ADDENDUM NO. 1

This addendum includes Item Number 1-1 thru 1-76. This addendum item shall be fully incorporated into the Bidding/Contract Documents and have the same force and effect as though originally included.

Life Sciences Collaboration
1910 N. Antelope Valley Parkway
Lincoln, Nebraska
TCEP No.: 716-002-12
Davis Design.: 12-0077
BVH No.: L12018.unl
November 27, 2013

Item 1-70: Sheet E1.21 – Second Floor Lighting Plan – Area ‘A’

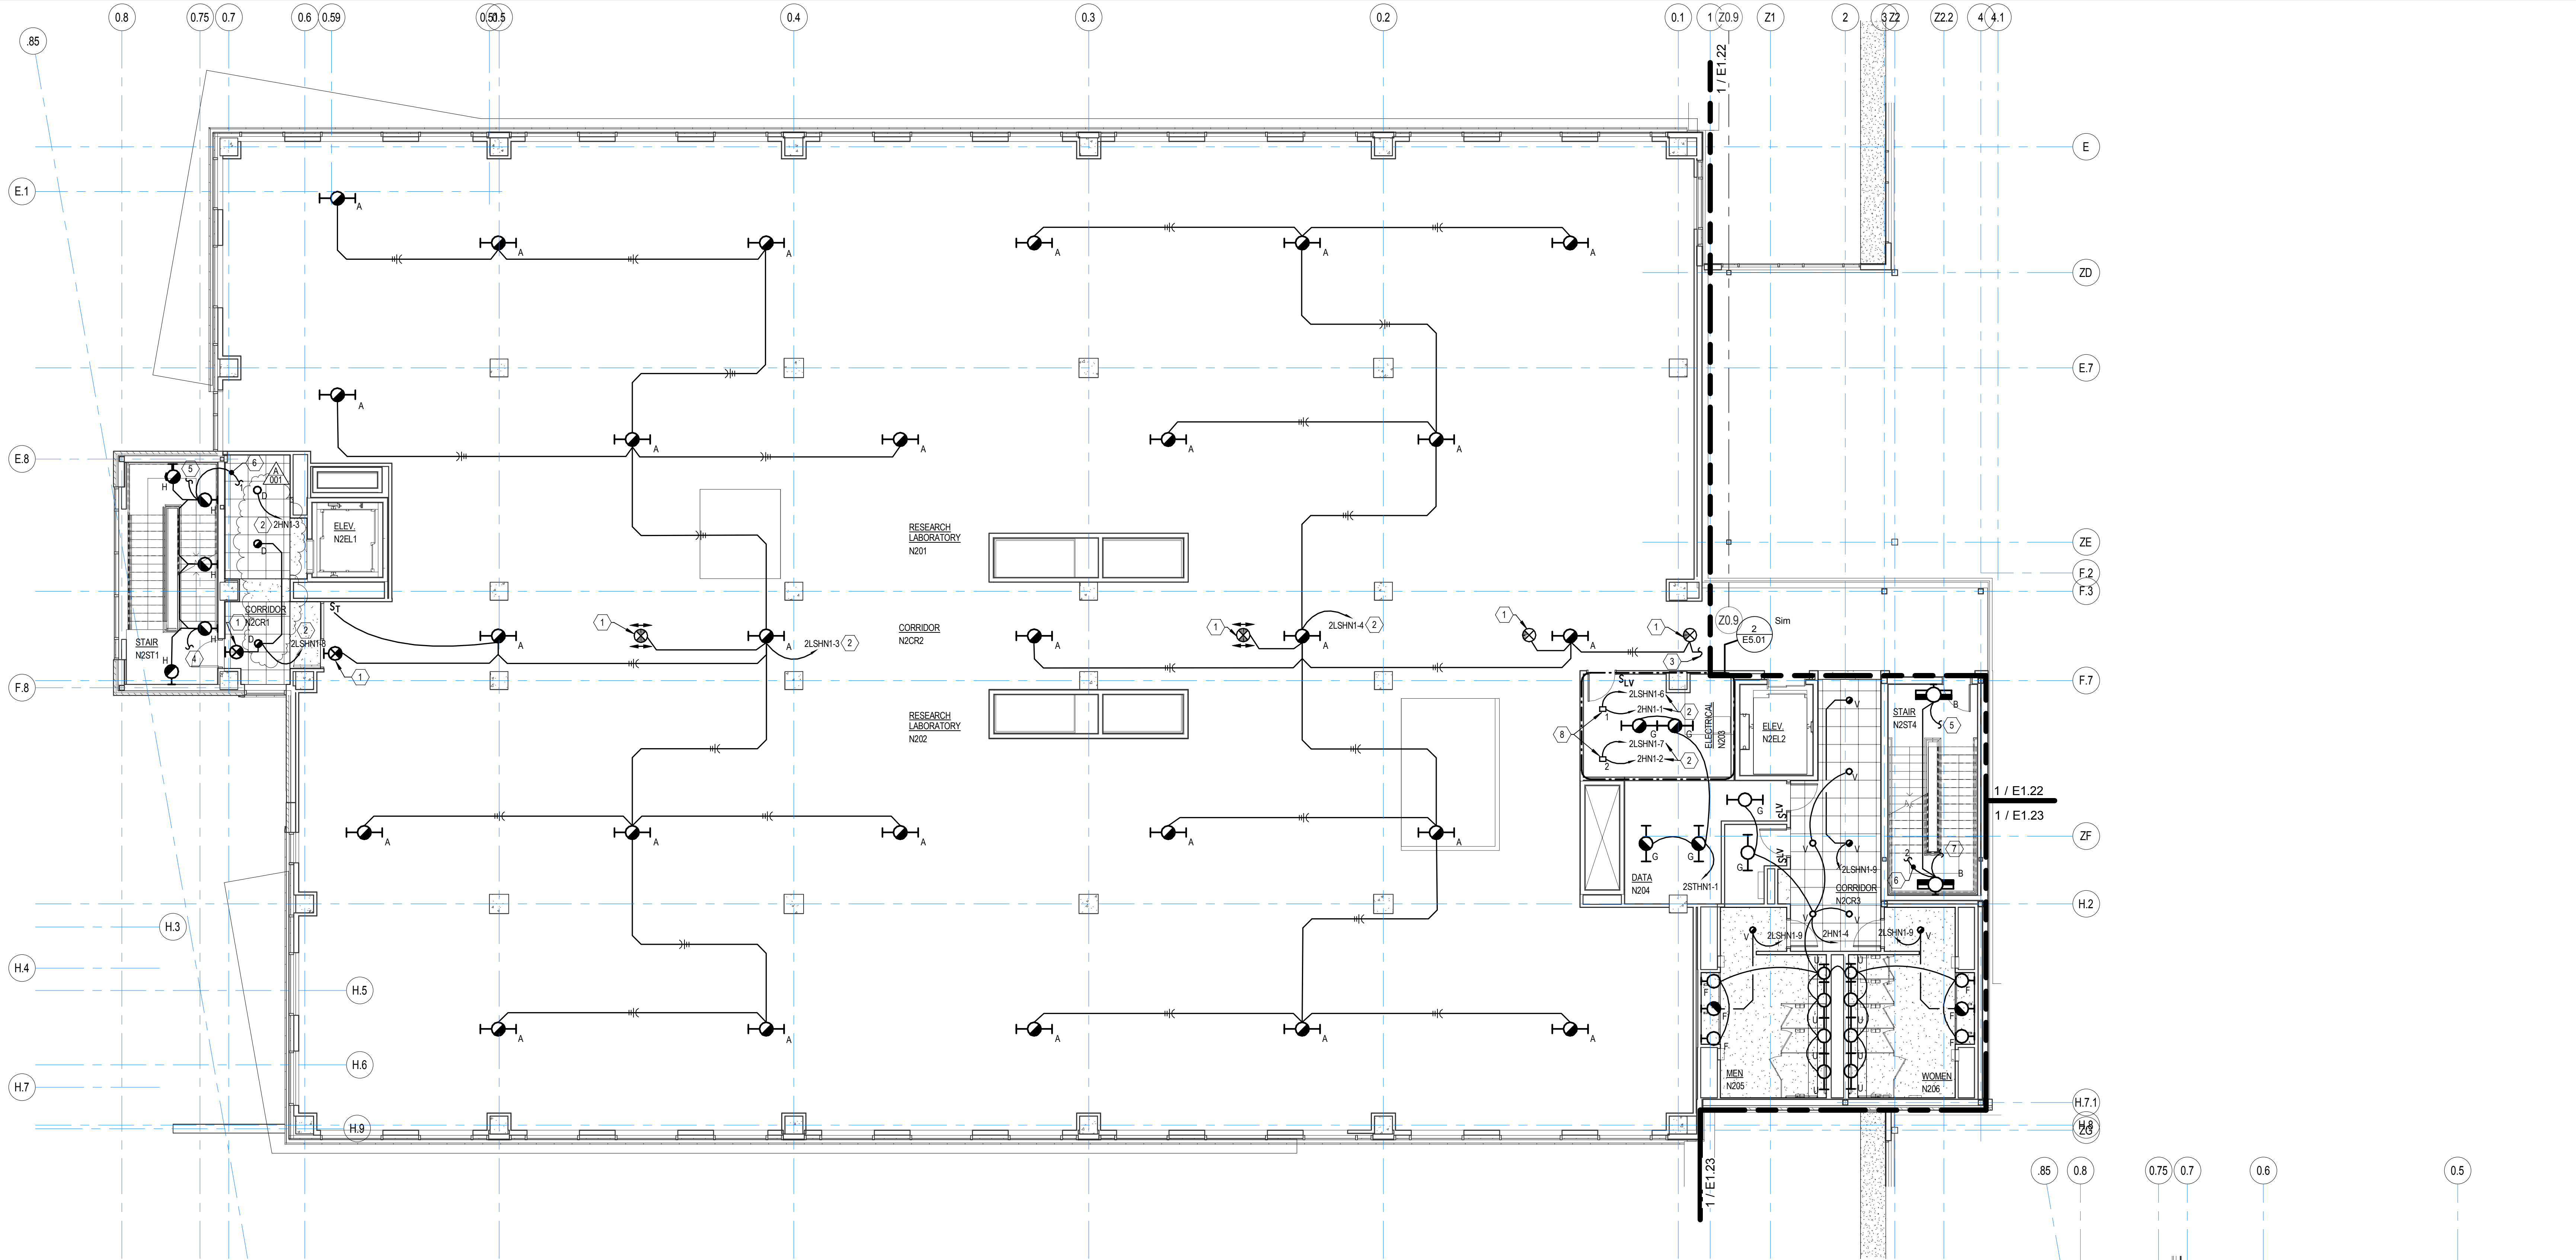
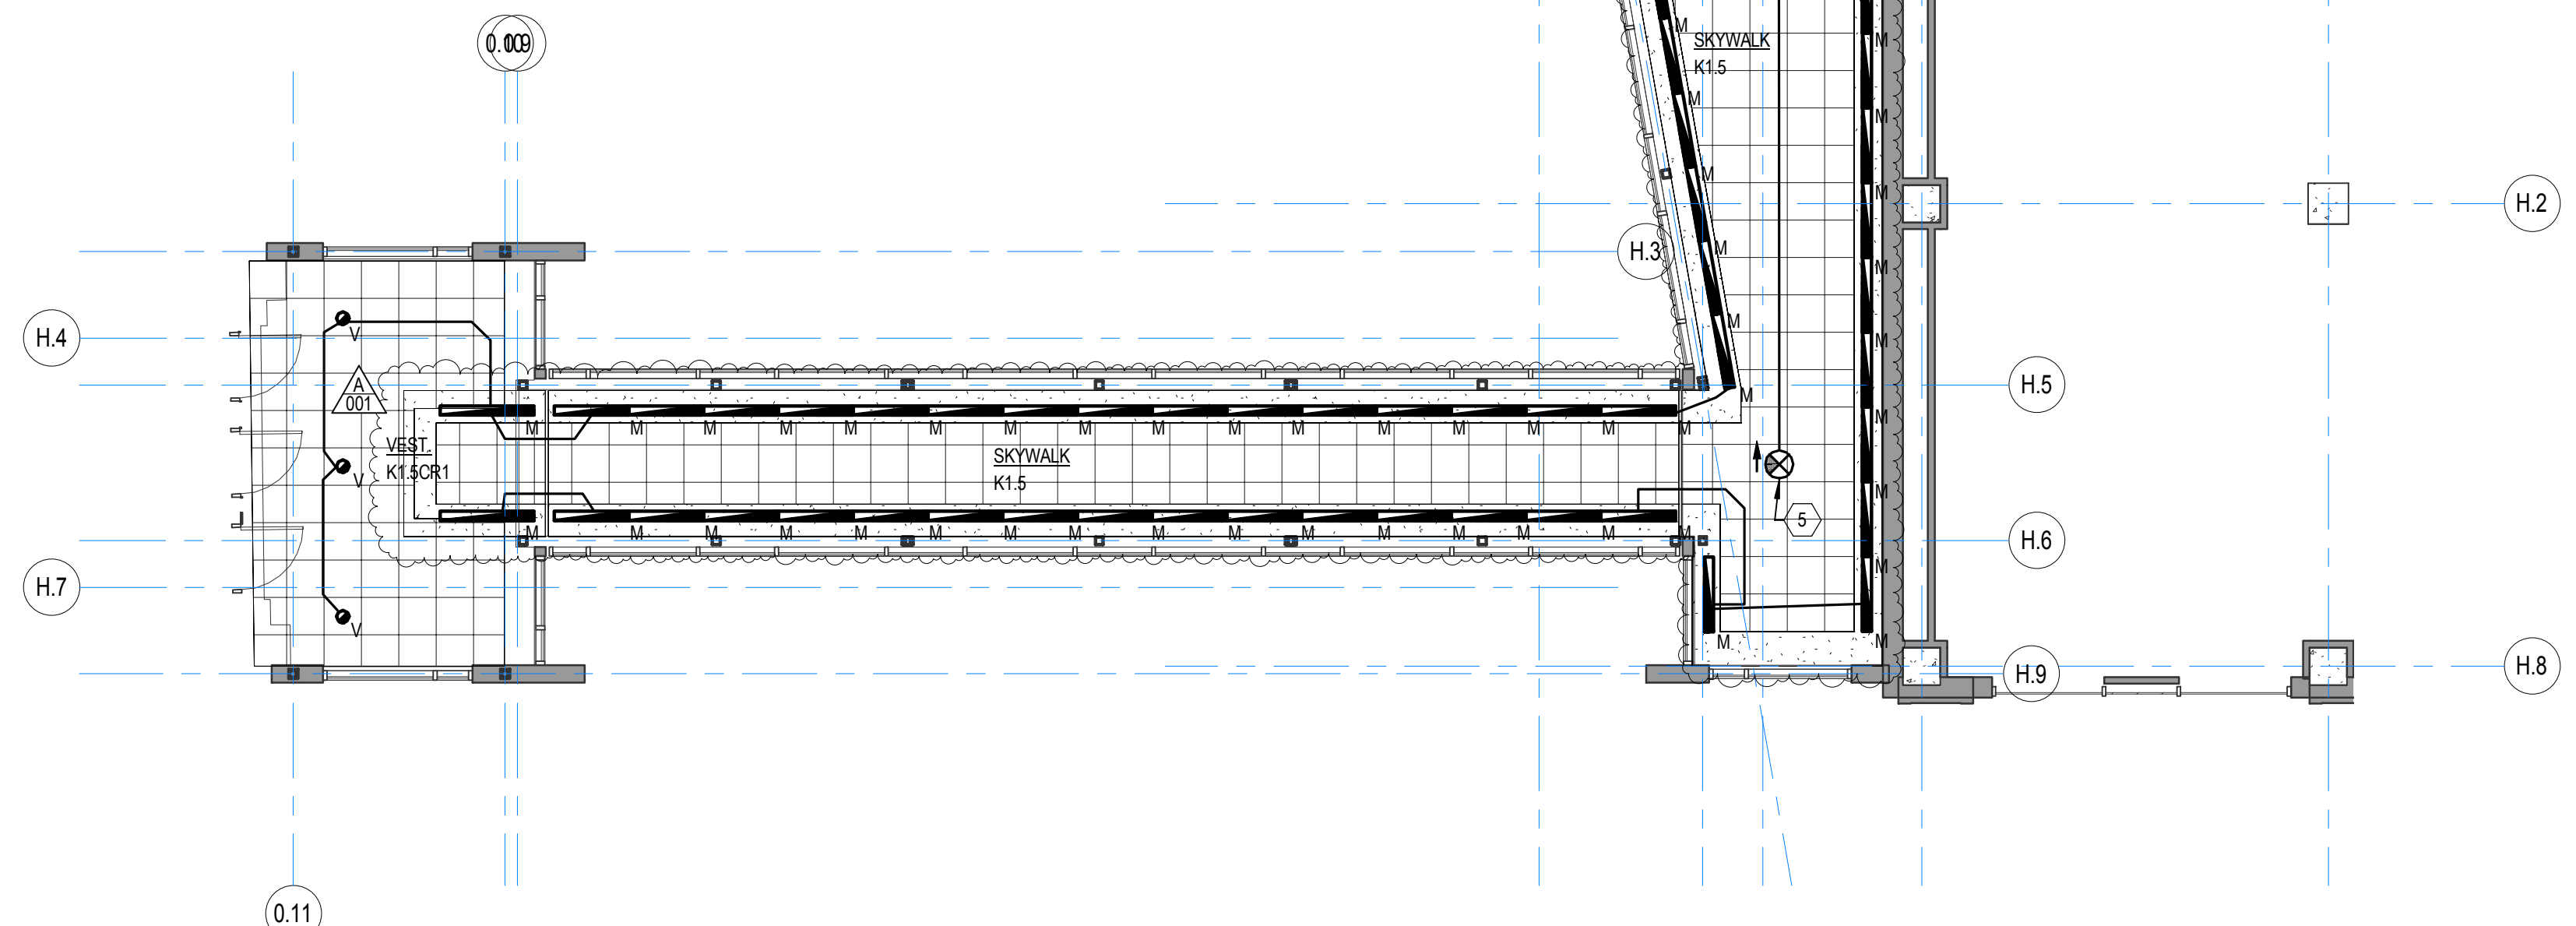
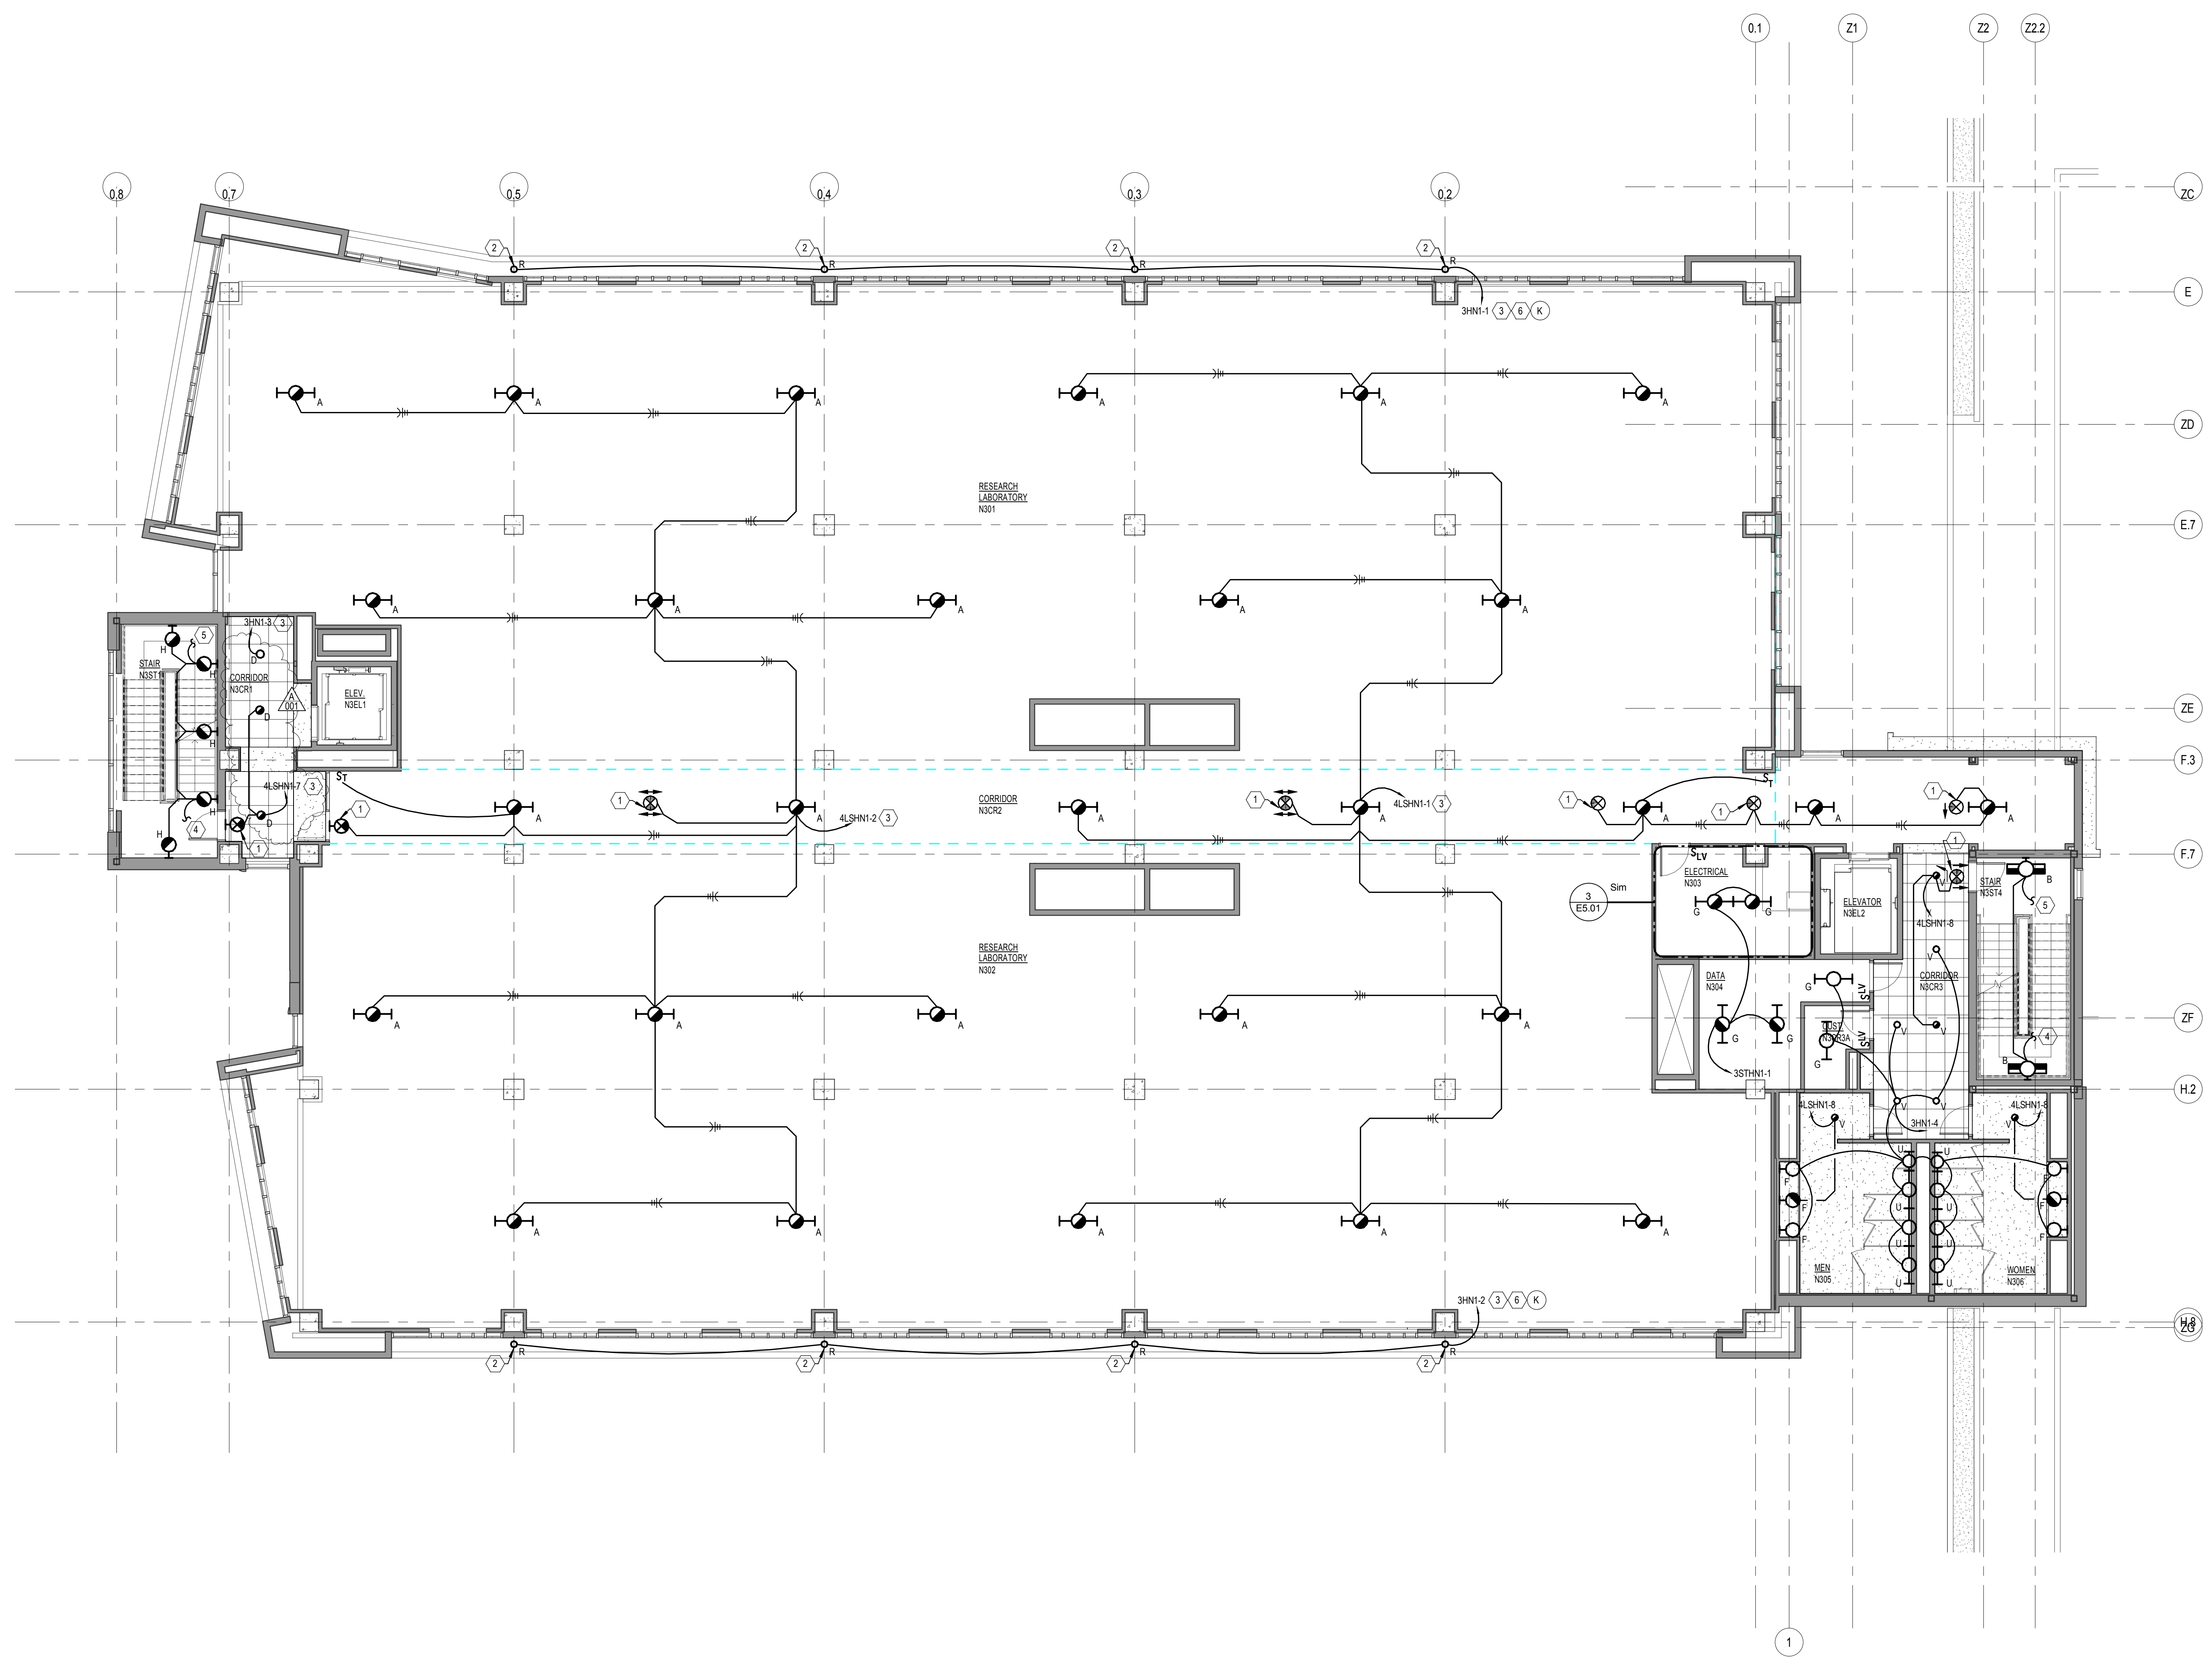
Reference Second Floor Lighting Plan – Area ‘A’: Switch Type ‘V’ fixture to Type ‘D’ fixture in Corridor N2CR1 and adjust layout.

Reference Skywalk Lighting Plan: Switch Type ‘V’ fixture to Type ‘D’ fixture in Corridor N1.5CR3 and adjust layout. Adjust Type ‘M’ fixture layout to match new ceiling layout in Skywalk. See re-issued sheet E1.21 for changes.
